05022 Version 2

Ticking from the Dashboard or Front Damper

Supersedes 13-039, dated October 23, 2013, see REVISION SUMMARY.

Year	Model	Trim	VIN range
2014–15	MDX	ALL	ALL

FRONT DAMPER MOUNT STIFFENER

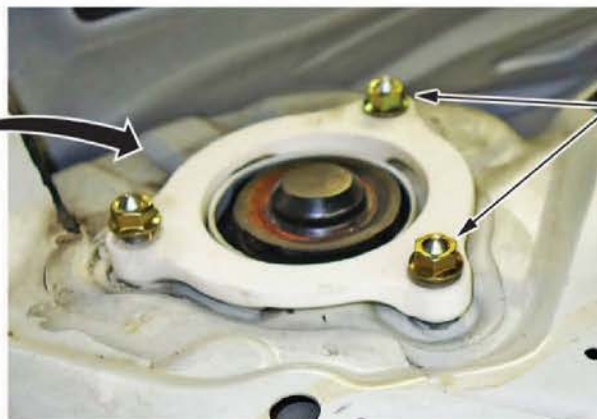
Paint from the front damper mount is sticking to the vehicle body, causing a ticking when the body flexes.

6. Clean the areas of the body where the front damper mount stiffeners will be installed. Make sure they are clear of any oil or dirt.
7. Install the front damper mount stiffeners with the flat side up as shown. The stiffeners are marked **L** for driver side and **R** for passenger side, be sure to install them in the correct locations.

NOTE: When correctly assembled, the stiffener should only touch the body with the raised areas on the bottom side of the stiffener.

Install with the flat side up.
Stiffeners are marked Right and Left.

NEW NUTS (3)
Initial torque:
49 N·m (36 lb-ft)
Final torque:
94 N·m (69 lb-ft)

8. Install the new nuts, and torque them in two stages. First, tighten all three nuts to an initial torque of **49 N·m (36 lb-ft)**. Then, tighten all three nuts to a final torque of **94 N·m (69 lb-ft)**.

NOTE: **Do not** use the original nuts with the front damper mount stiffeners.
